City of Richmond
Urban Development Division

Report to Development Permit Panel

To: Development Permit Panel
From: Joe Erceg
Manager, Development Applications
Date: April 28, 2003
File: DP 03-223538
Re: **Application by Care Enterprises Ltd. for a Development Permit at
8091 Bennett Road**

SITE PLAN
SCALE: 1" = 10'-0"

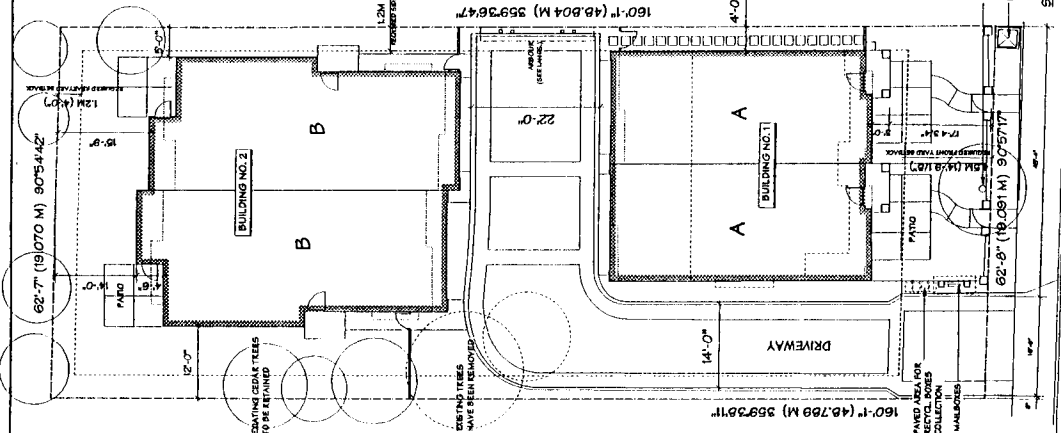
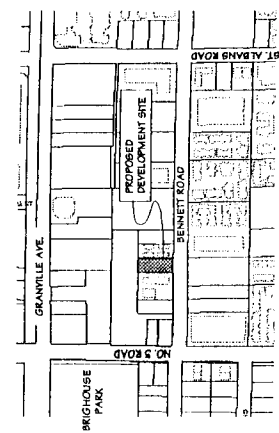
1. Throat width of driveway to Bennett Road should be minimum 5.1 m (as was accepted for 7831 Bennett Road; similar 4-unit development). Rezoning drawing showed 18.5 ft. (5.64 m). *see analysis.
2. For vehicles to turn around in the back; should have minimum 6 m to manoeuvre. *There should be adequate space for the small number of residents to manoeuvre.*

No building concerns. What is the distance between the front and rear buildings? Can a vehicle be comfortably turned around in this space? *The distance between the front and rear buildings is 7.7 m (25 ft. 6 in.).*

Okay with the concrete pad. Turn the letter box around so that the Mailman will not trip over the garbage containers or recycling boxes. *Mail boxes are facing the walkway/driveway, and there is an adjacent paved area for blue boxes.*

Consider a trellis with vines at the east end of the driveway, to improve the appearance of this area and to screen the adjacent property. The landscape architect has added an arbour at the end of the driveway.
- Parking reduction opportunities should be sought through the sharing of parking facilities and coordination with the off-site opportunities. **We note that you exceed the bylaw parking requirement by two (2)spaces.**

*Regarding the driveway width, throat width and sidewalk, we note that the Design Panel suggested a sidewalk and the Transportation Department suggested a wider "throat width". Nevertheless, the driveway width should not be increased at the expense of green space. It should be possible to vary the width or add a de-facto sidewalk with different paving, multi-use of paved areas, etc. Also, there is an existing driveway to the west, so the de-facto throat width is wider.

PARTIAL MAIN FLOOR PLAN

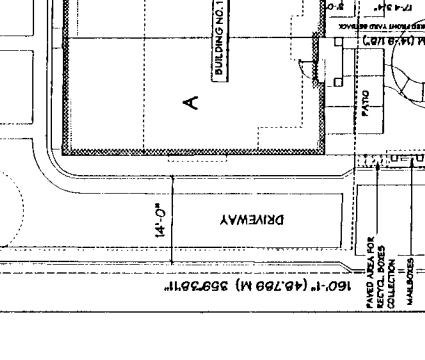
Consider making one unit more accessible on the ground floor by deleting one (1) parking space and adding a bedroom on the ground level. Alternatively, provide a plan of how this could be accomplished at a future time should a purchaser with special needs come along (lifts, etc.). The architect has provided a design for a unit which can be easily converted to universal accessibility, with space for a lift, etc.

UNIT B - UNIVERSAL UNIT CONVERSION
MAY 2 2003
#1
DP03.223538
